Sacramento Commons

Final Environmental Impact Report

State Clearinghouse No. 2014042032

June 2015

Figure 2-3. New Development in Parking Areas Only

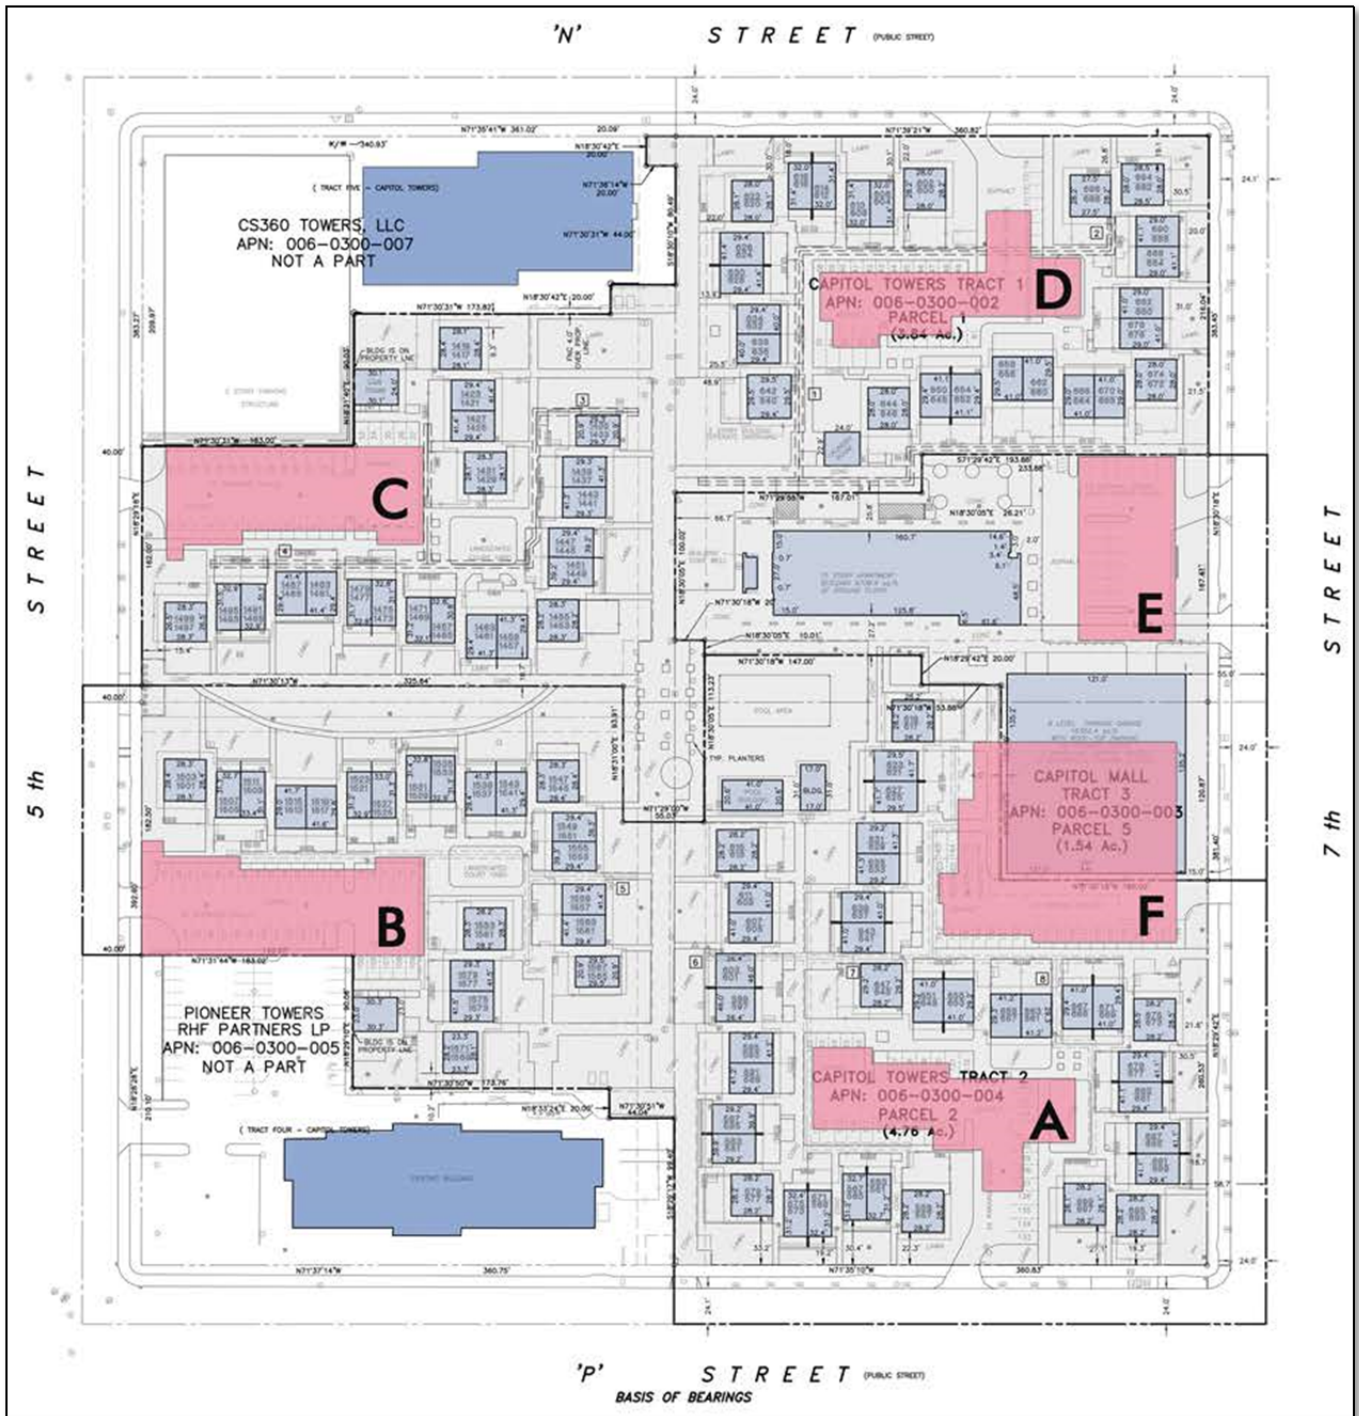
New Development Only in Parking Areas

Pursuant to the Secretary of the Interior's Standards for the Treatment of Historic Properties, the Standards for Rehabilitation may include related new construction that will not destroy historic materials, features, and spatial relationships that characterize the property. Some commenters identified a "New Development Only in Parking Areas" alternative as a potential rehabilitation alternative. Specifically, in order to permit new infill construction alongside the historic buildings and landscaping onsite, some commenters proposed an alternative in which new development would only occur within the existing parking lots on the project site and within the footprint of the existing parking structure. As explained further below this alternative poses policy issues from a City policy perspective and would not be able to accommodate the density included in the proposed project.

The “new development only in parking areas” alternative allows for development within the areas shown in Figure 2-3.

The unit estimate for this alternative assumes the City would authorize a tower with a footprint this large notwithstanding that the Central Core Design Guidelines encourage more slender towers to be developed; reducing the footprint of this tower to 17,000 square feet consistent with the maximum proposed footprint in the proposed project would result in a reduction of approximately 44 units. Finally, the remaining two developable parking lot areas along 5th Street are each assumed to include 24-story residential high-rise towers as shown in Figure 2-3.

Figure 2-5. Consolidate Parking Structures and Residential Towers

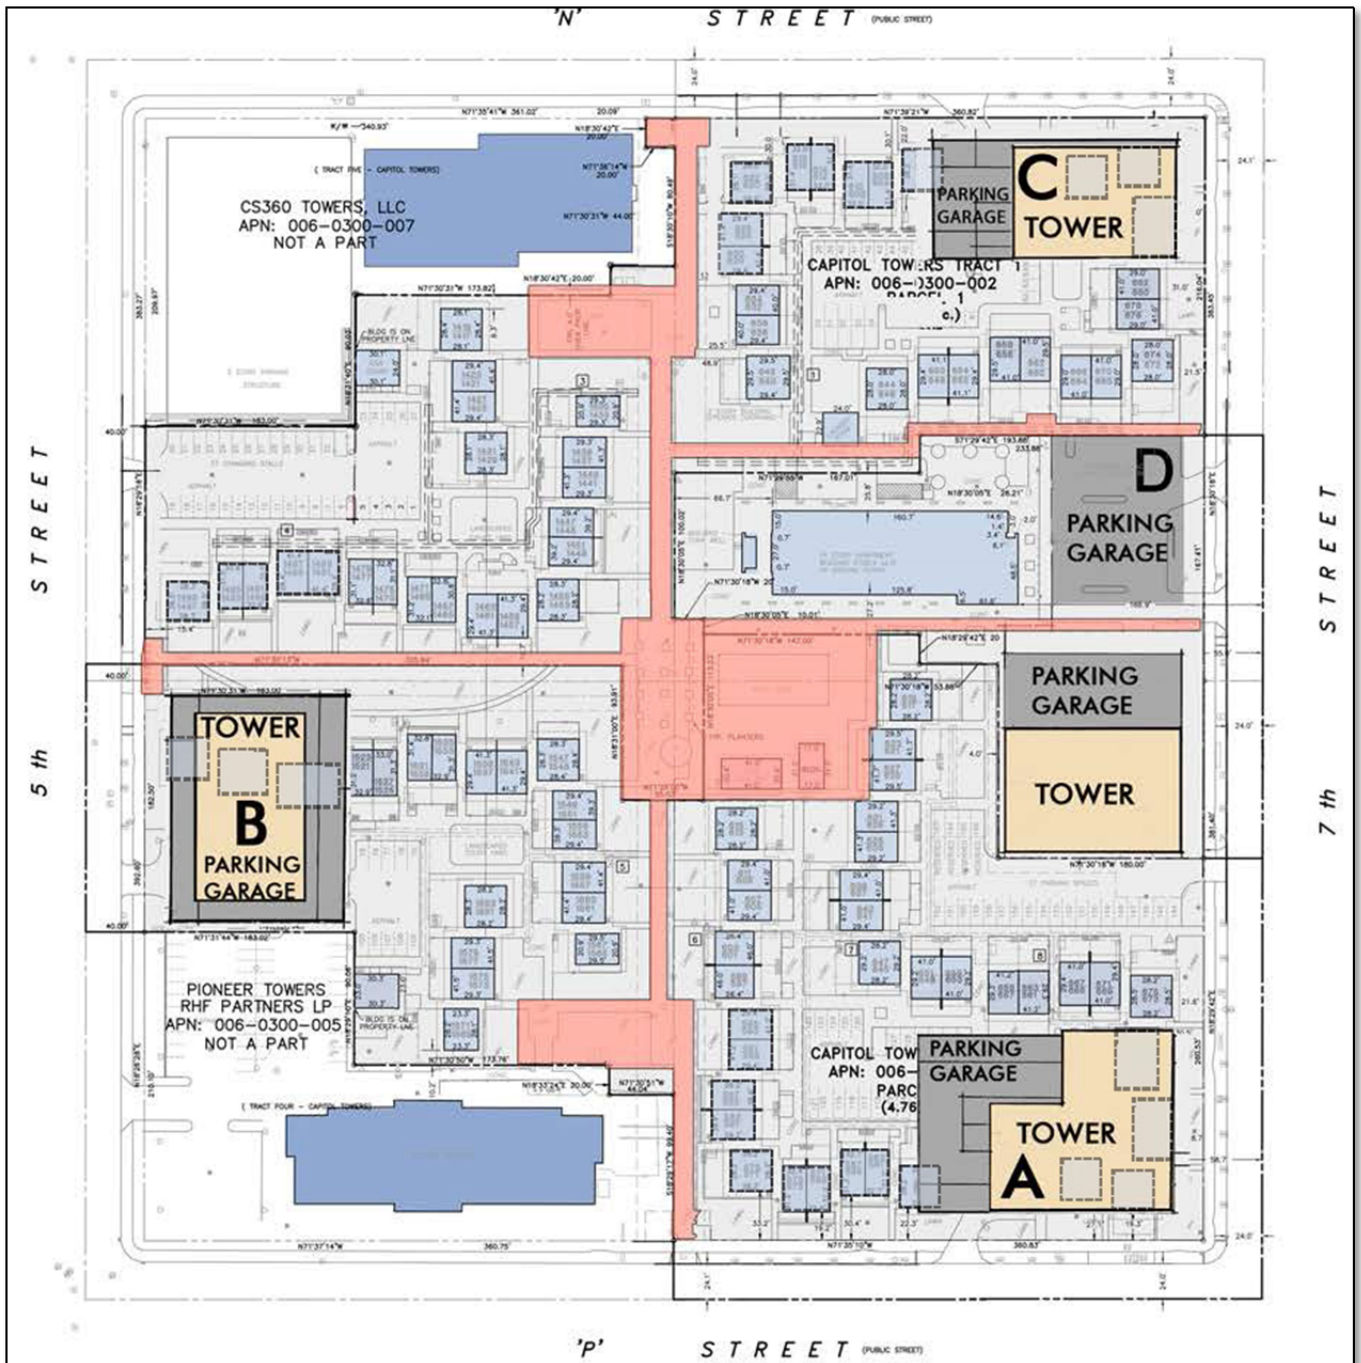
(2) Consolidate Parking Structures and Residential Towers

As shown in Figure 2-5, if a podium level of parking was included below each residential tower and Alternative 2's 15-story maximum height was retained, then this variation of Alternative 2 would allow for 352 new units and provide for a total of 727 units on the project site; approximately half of the total units included in the proposed project. As shown in Figure 2-5, if a podium level of parking was included below each residential tower and the City's Planning and Development Code-allowed maximum height of 24-stories was maintained as in Alternative 3, then this variation of Alternative 3 would allow for 692 new units and provide for a total of 1,067 units on the project site; approximately a 20 to 30 percent reduction in units as compared to the proposed project.

Like Alternatives 2 and 3, consolidating the parking garages with the high-rise towers would not be sufficient to reduce the historical resource impacts under Alternatives 2 and 3 to a less than significant level since there would be demolition of a significant number of contributing buildings and the new construction of towers will impact the landscape, which also contributes to the district's eligibility. In addition, more than three aspects of integrity would be impacted. In addition to design, setting, and feeling there would still be an impact to the property's integrity of materials and workmanship because there would be demolish of contributing buildings (Ambacher 2015).

Figure 2-6. On-Site Easements

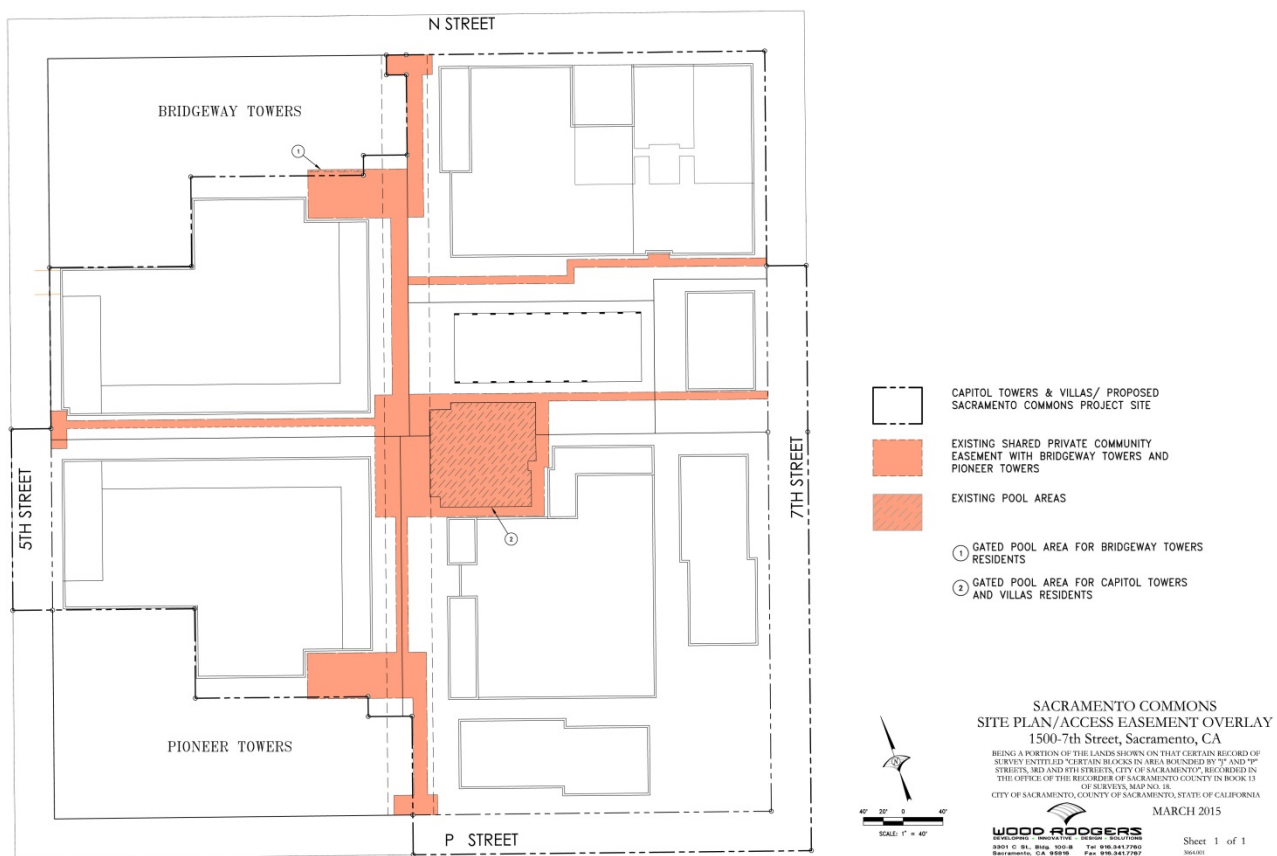
Some commenters identify the presence of on-site easements and ask about their continued use following development of the proposed project. Some private community easements remain on the project site, as identified in the attached figure (Figure 2-6). The private community easements grant the Pioneer Towers property and the 500 N Street (also known as Bridgeway Towers) property use of the easement areas identified in the exhibit below for right-of-way and recreational purposes. As shown, the private community easements are located within the East-West Promenade, North-South Promenade, and other pedestrian pathways included as a part of the proposed project.

The existence of private community easements does not have any bearing on the evaluation of the potential significance of park and recreation impacts caused by the proposed project. The grant
